Re: Initial Submission Review – Comment Response Letter –
Stafford Logistics Center Trailer Parking – Master Plan Admt, Site Plan, and Plat Application Number:
DA-2170-06

Case Numbers: **2019-7001-03; 2023-6014-00; 2023-3011-00**

Initial Submission Review

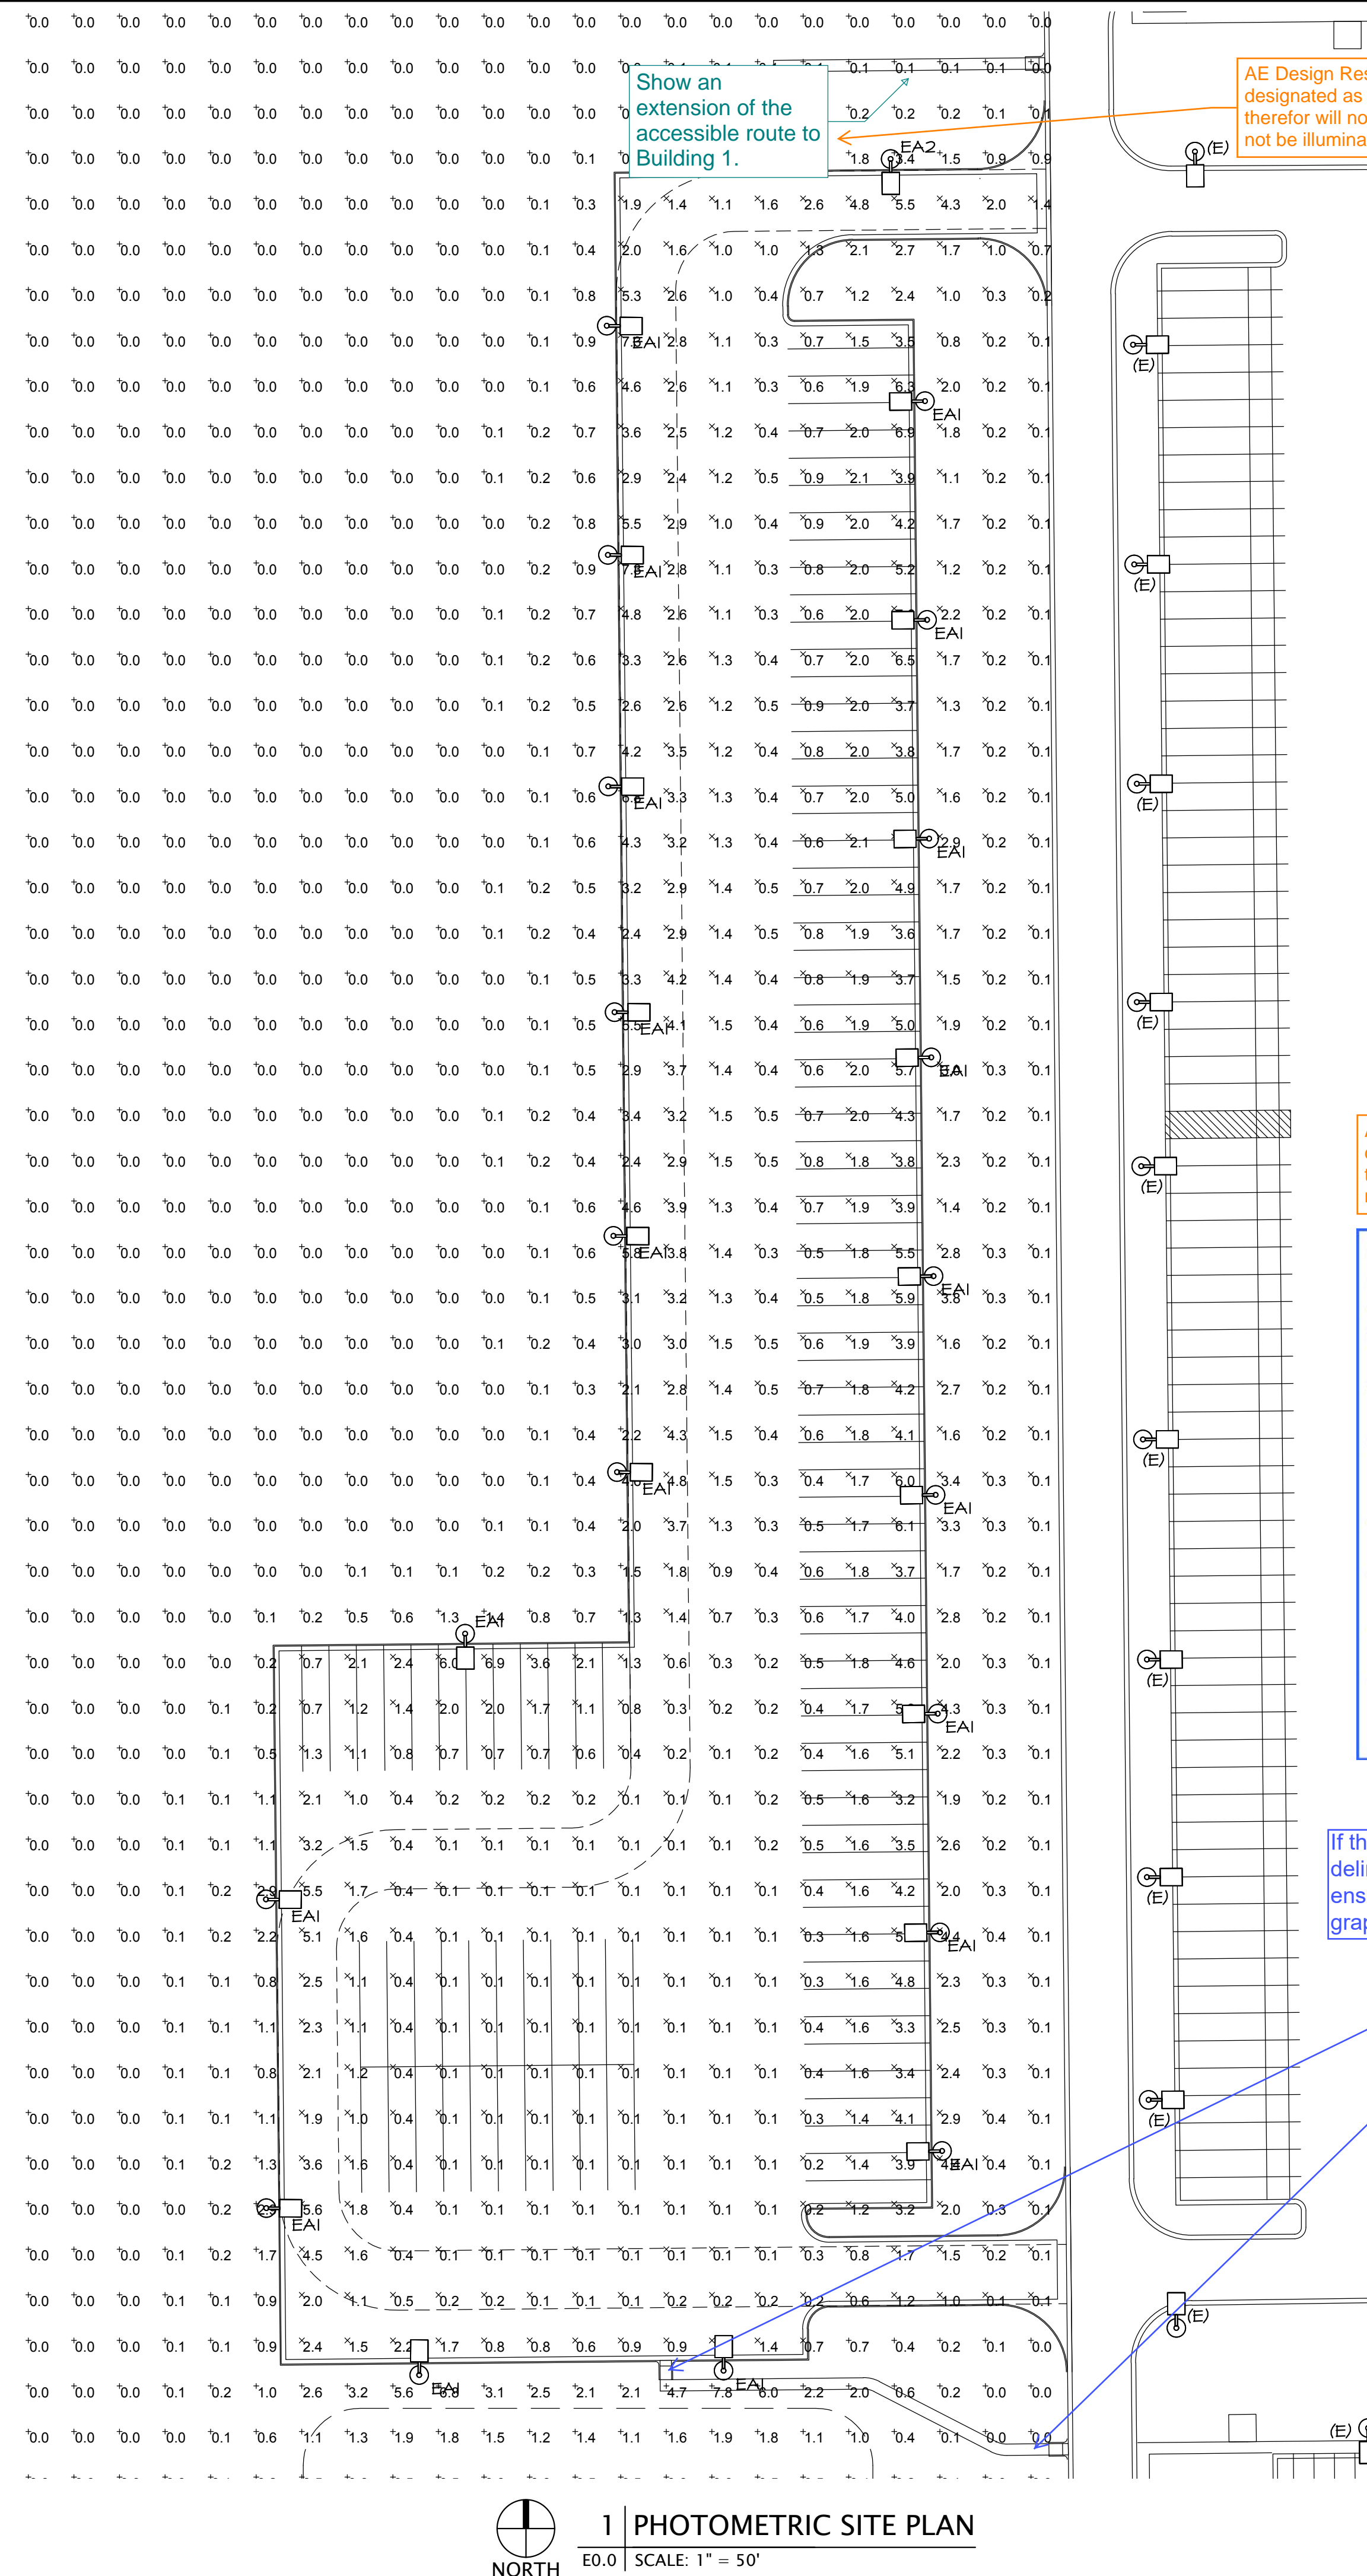
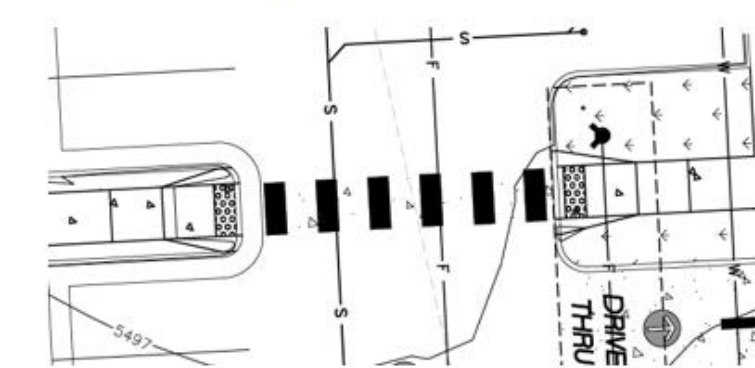
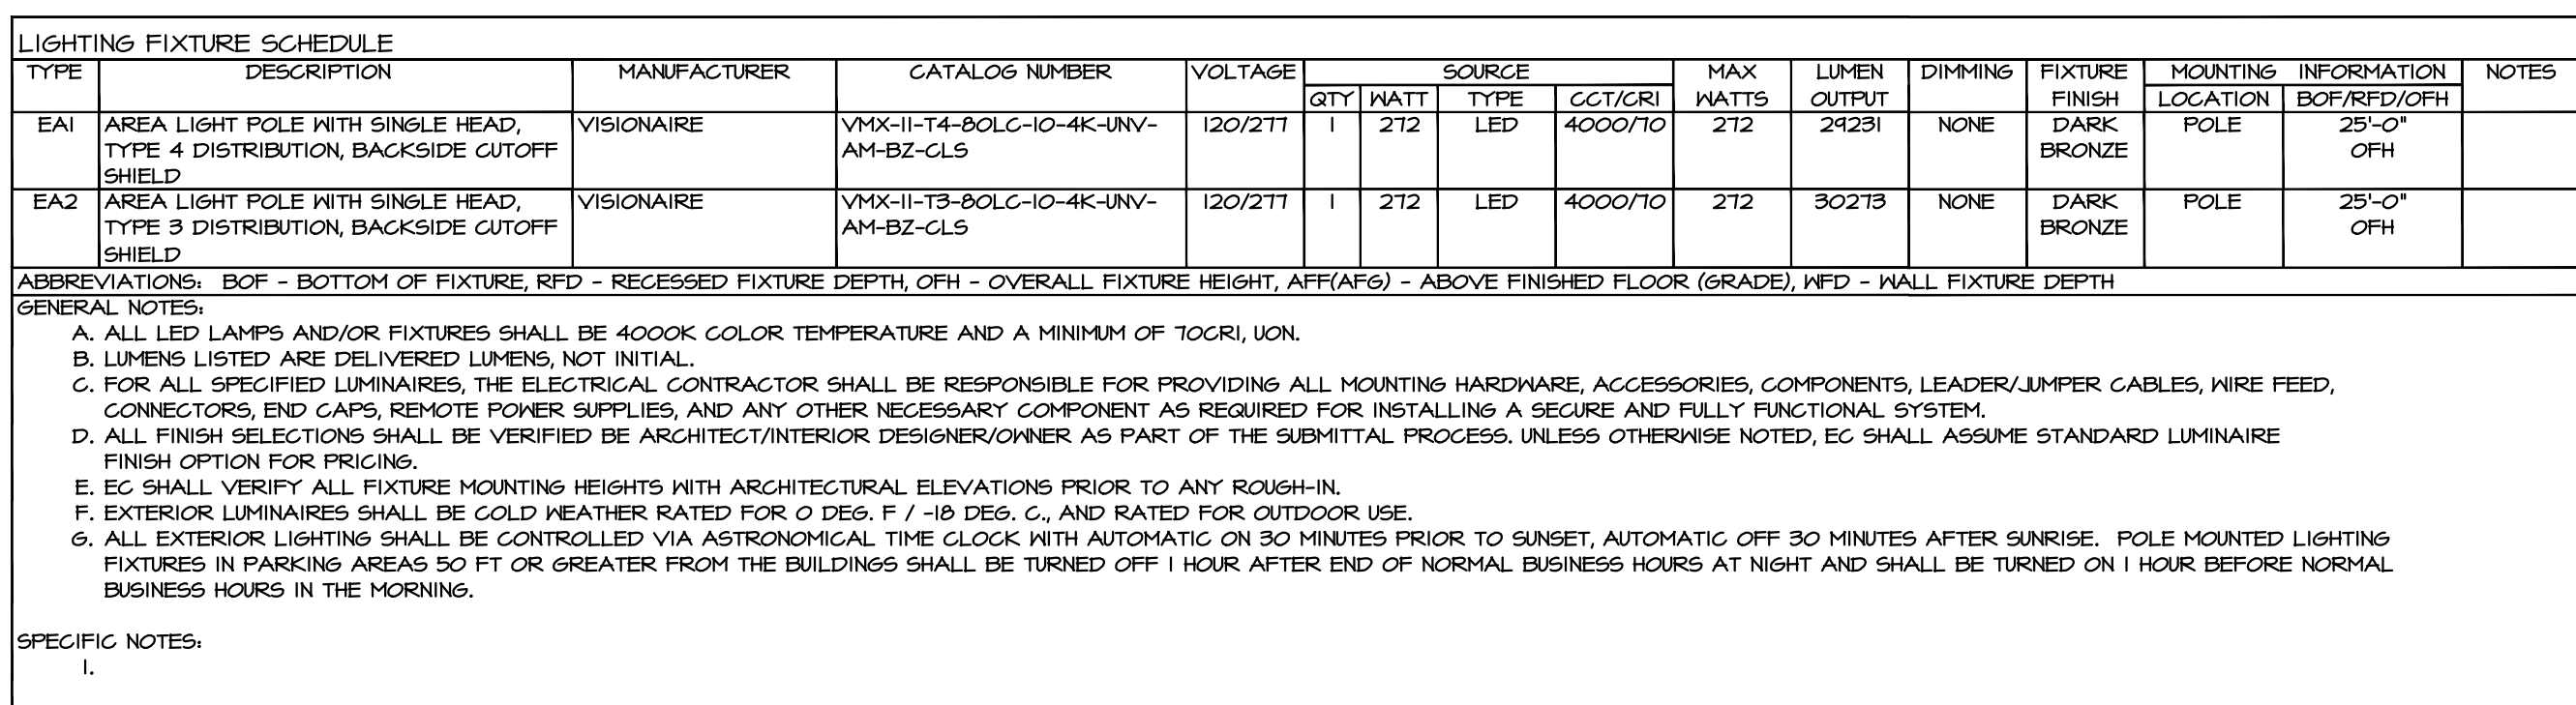
- Using a heavy dashed delineation and label show the exterior accessible route of travel throughout the site plan to:
 - Public transportation stops.
 - Accessible parking and accessible passenger loading zones. This includes required accessible garages.

If this is designated an Accessible Route, delineate with a heavy dashed line and ensure the route is illuminated per the graphic provided.

The photometric plan must show and label the location of the internal site accessible route. Provide a minimum of 1 foot-candle of lighting within the accessible route.

Where an accessible route crosses a drive-aisle provide curb ramps and crosswalk.

AE Design Response: This walk is not to be designated as an accessible route and therefor will not be labeled as noted and will not be illuminated to minimum of 1 footcandle.
